Staff Report

Re: PLNSUB2016-01000 – Euclid Corners Townhomes

PLNSUB2017-00032 – Euclid Corners Preliminary Subdivision

Planned Development & Preliminary Subdivision

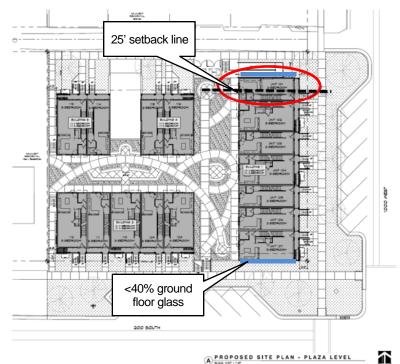
1. Modification of 25 foot setback requirement in side yard

The TSA-UN-T district does not require any setback for this district unless the property abuts certain residential districts. In this case the property to the North is zoned RMF-35, and requires a 25 foot setback from the property line with one foot of step back of one foot for every one foot

in height over 25 feet. The proposed setback is approximately 17 feet resulting in an approximate **eight foot encroachment** into the setback, and will require a modification through Planned Development approval. The alley abutting this required yard is 16 feet wide and with that included, the distance from the buildings to the property line will be 33 feet and the nearest single family home being an approximate 60 feet from the alley. The applicable area is shown on the right in the red oval.

2. Modification of first floor glass requirement

The second modification requested is for a reduction in the first floor glass requirement. The street facing front entrance facades of each unit meet the first floor glass requirement of 40%

glass, between three and eight feet above grade for residential uses. The North and South ends of the East facing units (shown in blue on the above) face public rights of way and have approximately 10% glass proposed. This does not meet the standard due to internal functions of the building, and the floor level being four feet above grade. The glass being proposed on the elevated ground floor is 25% however. The applicant has made substantial effort to meet the intent of the ordinance with windows spanning the length of the façade, including one large bay window and several clerestory windows.

A 1000 WEST ELEVATION (EAST ELEVATION) SCALE: 1/8" = 1'-0"

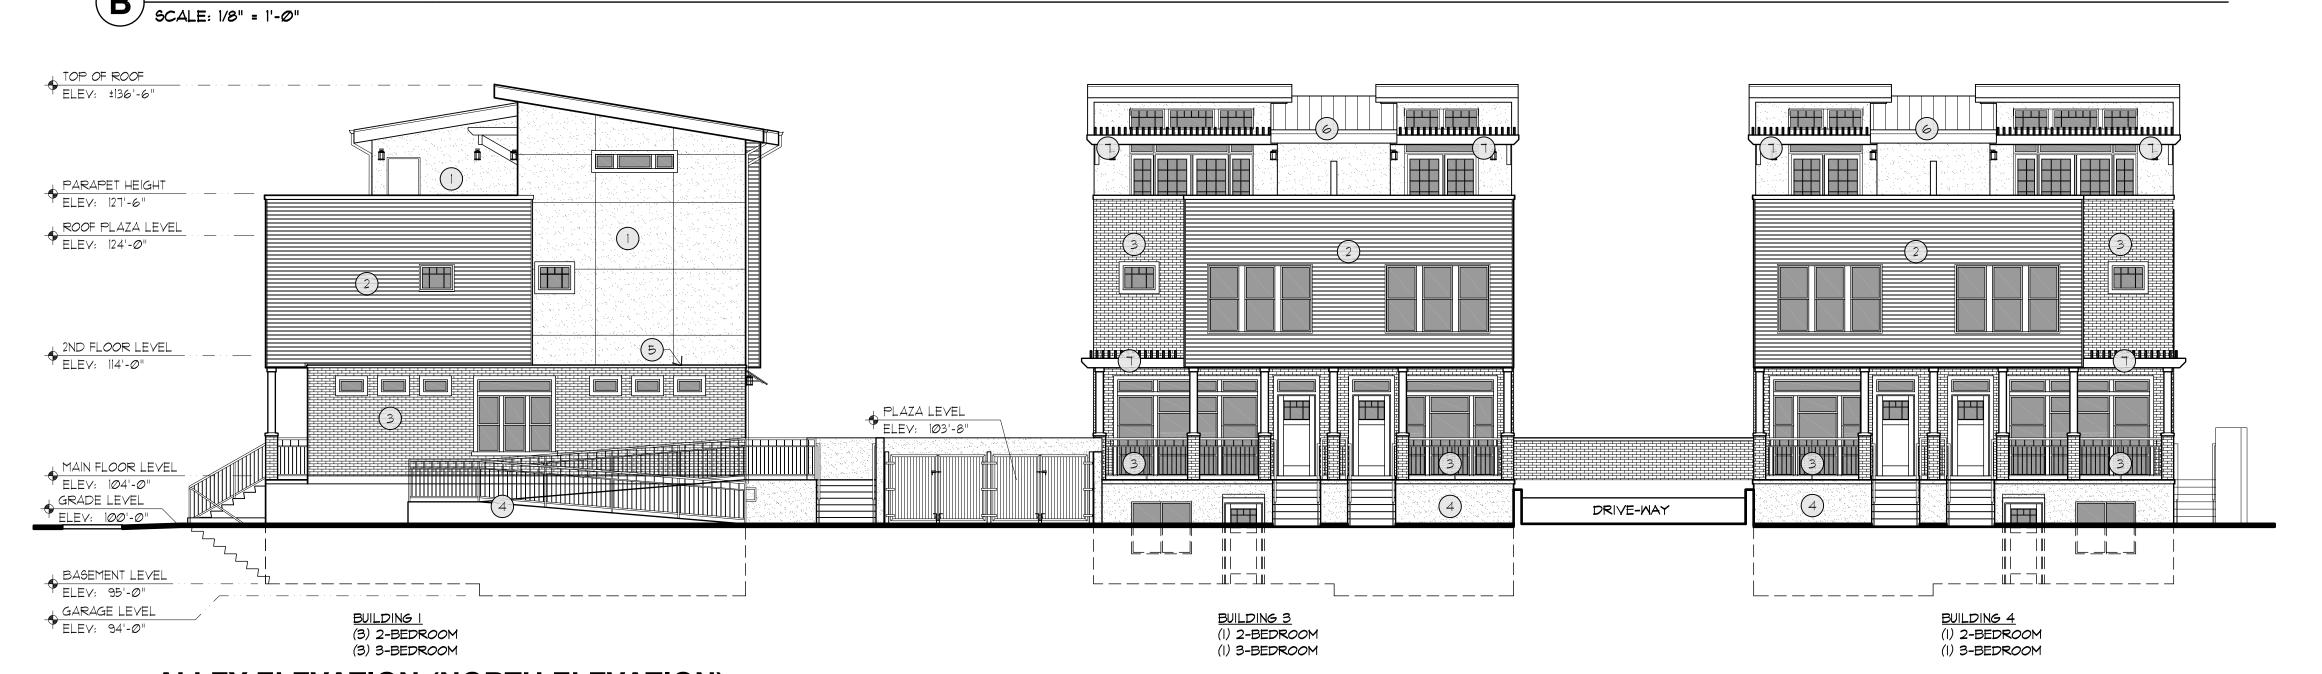
The end units facing 200 South and the public alley would typically be required to provide 40% glass between 4 and 8 feet and approximately 10% is being proposed. In this area of the buildings, the facades are limited by mechanical and interior function of the building. At these locations, the applicant has worked with staff to include a large window in the center of each façade, and place smaller clerestory windows across the remaining façade area. In addition, the applicant has worked with staff in adding the same window treatment to interior and side yard facing facades where none are required.
